AUDIO SIGNAL PATH

DESIGNED BY		RENKUS-HEINZ	
CHECKED BY		SCHEMATIC, RH23	
DATE	DATE	SCALE	DRAWING NO.
7-22-70			D
APPROVALS		DO NOT SCALE DRAWING

CONTROL CIRCUITS			
TOLERANCES UNLESS OTHERWISE SPECIFIED		RENKUS-HEINZ	
FUNCTIONAL SPEC. SHEET #		SCHEMATIC, RH23	
APPROVALS	DATE	SCALE	SIZE
DRAWN BY	DATE		D
CHECKED	DATE		
		DO NOT SCALE DRAWING	SHEET 2 OF 2

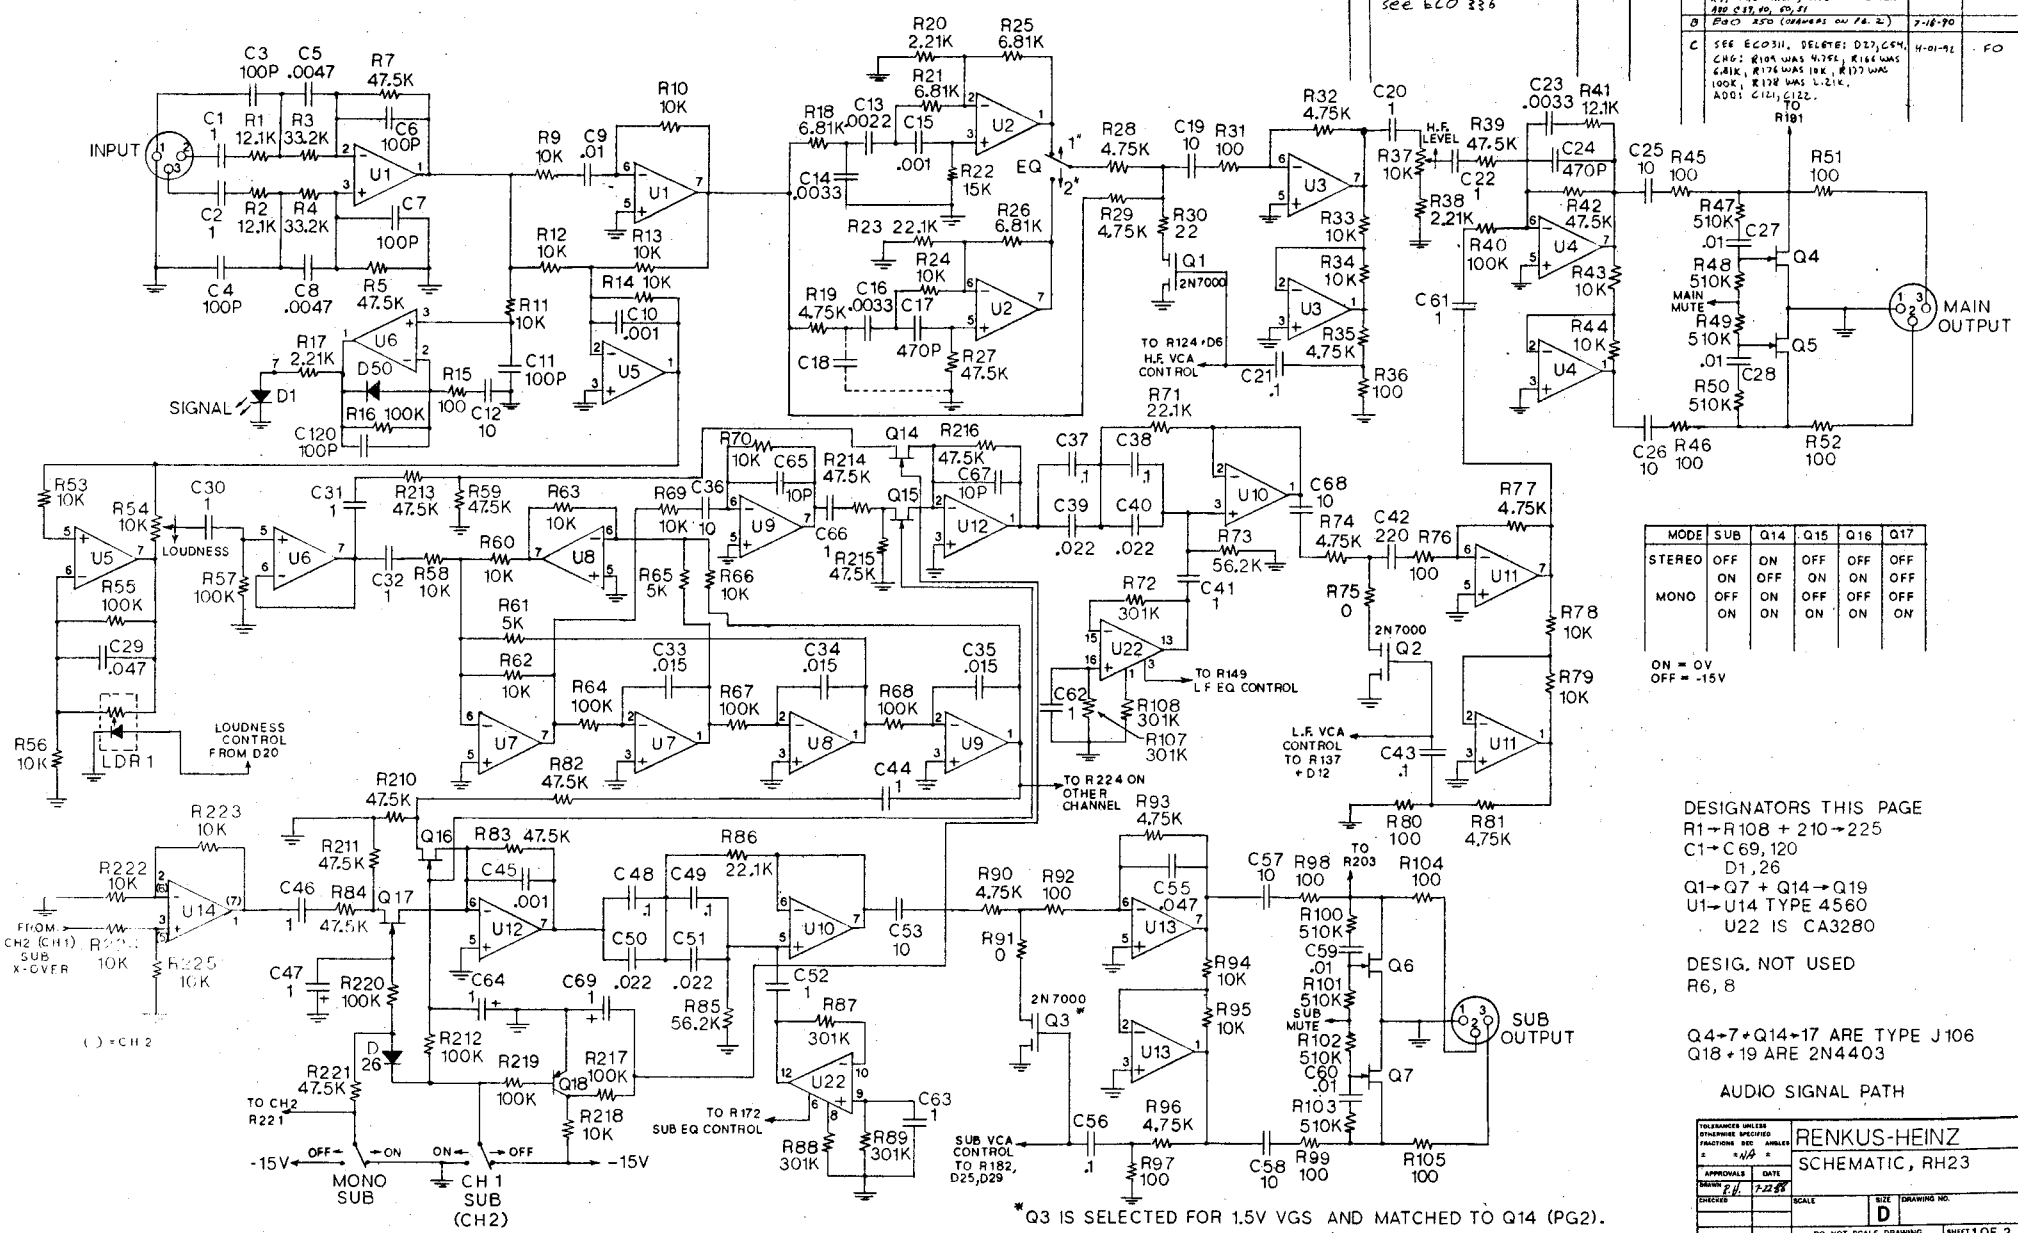
MOVED C20 FROM U3-7 to U3-1  
see ECO 336

REVISIONS			
LTN	DESCRIPTION	DATE	APPROVED
A	R96 WAS 33.2K, R97 WAS 33.2K R71 WAS 150K, R73 WAS 68.1K R80 C13, NO. 00.21	7-6-70	R.H.
B	PCO ASD (CONFORMS TO P.A. 2)	7-18-70	
C	SEE ECO 311. DELETE: D27, C24, C46; R104 WAS 4.75K, R166 WAS 6.81K, R176 WAS 10K, R177 WAS 100K, R178 WAS 1.21K. ADD: C11, C12.	4-01-92	FO

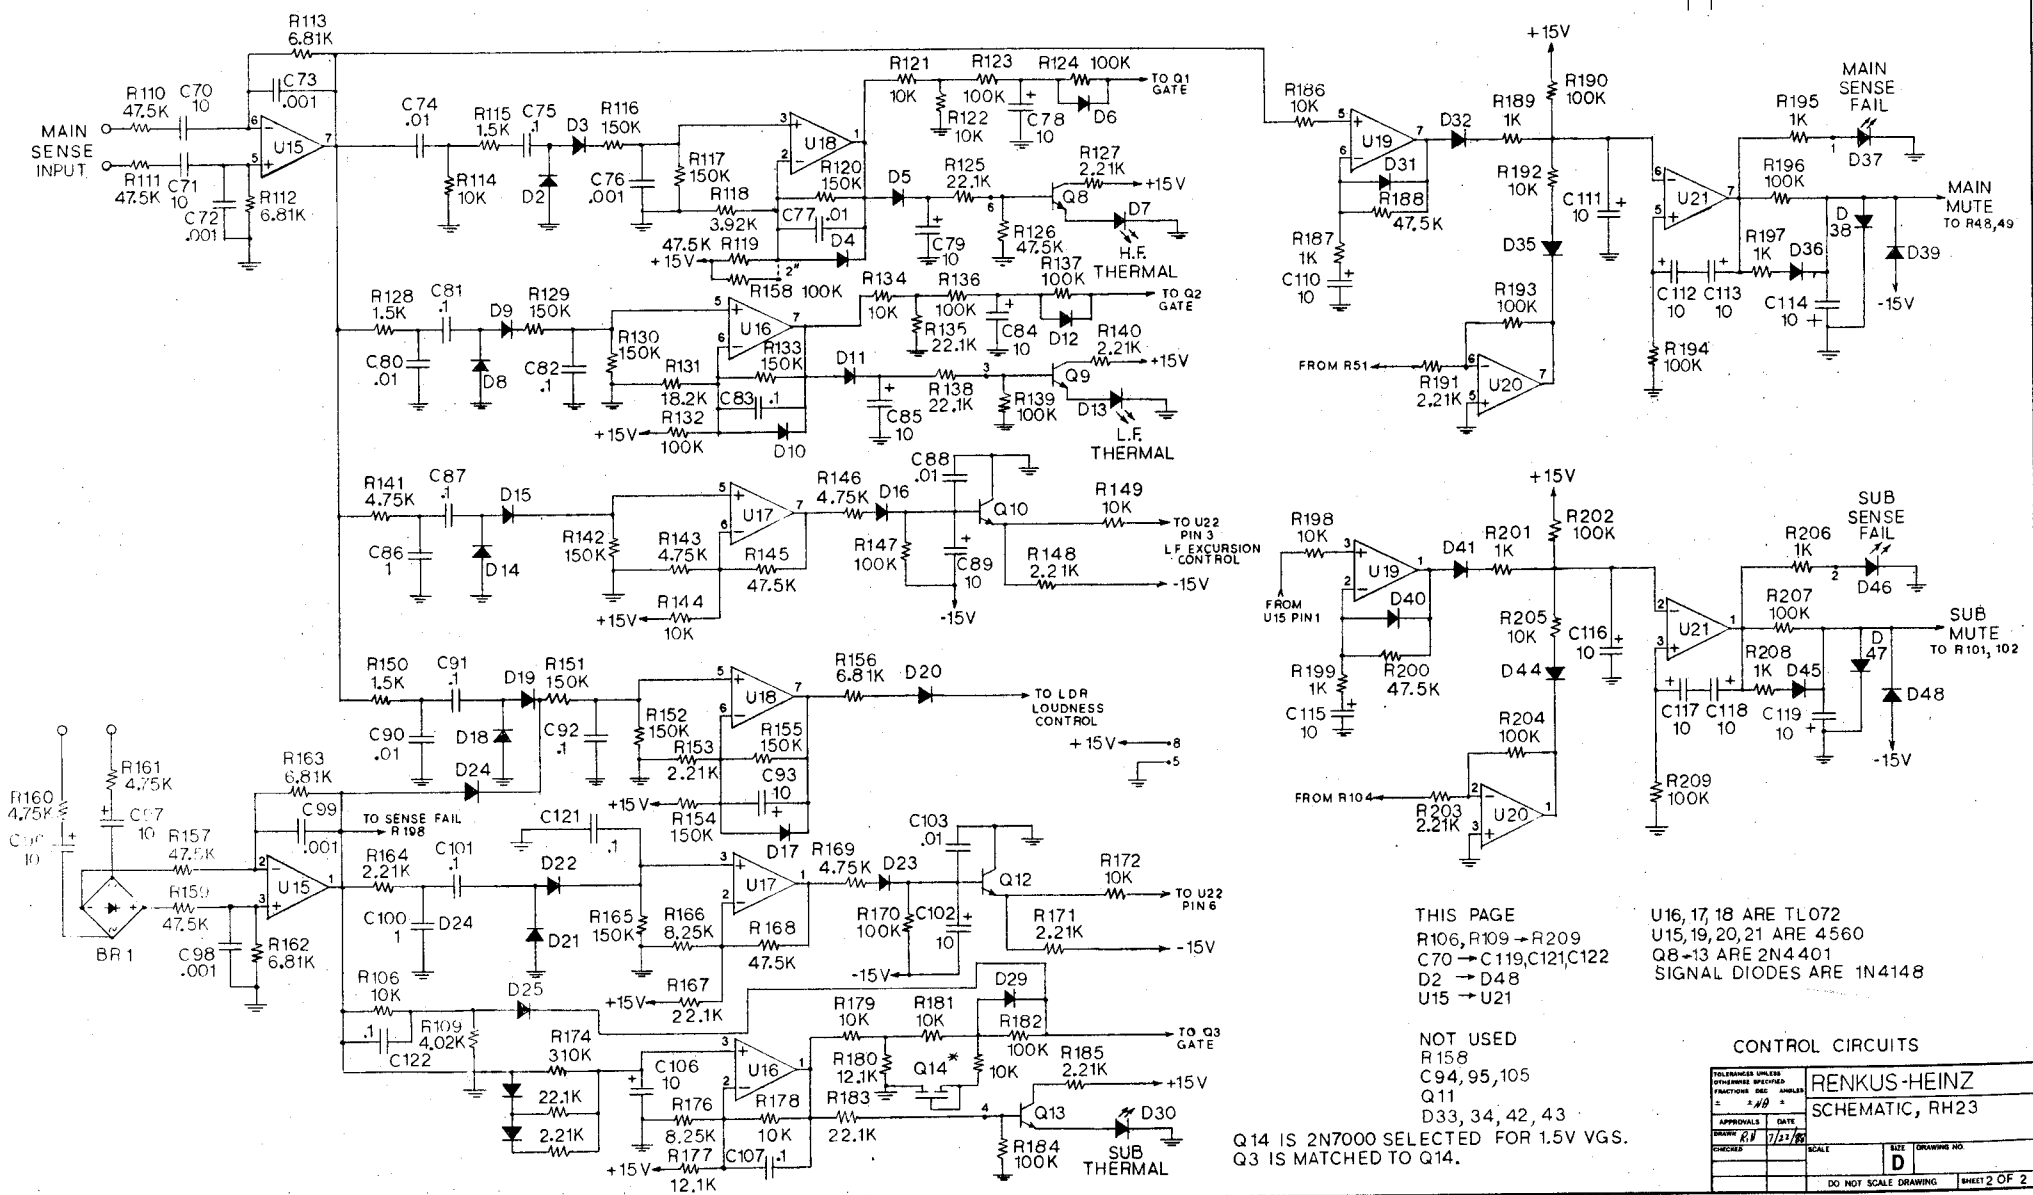
REVISIONS			
LT#	DESCRIPTION	DATE	APPROVED
A	SEE #1		
B	SEE ACO 250	7-16-70	
C	SEE PG 1	4/01/72	
D	SEE PG 1	8-3-72
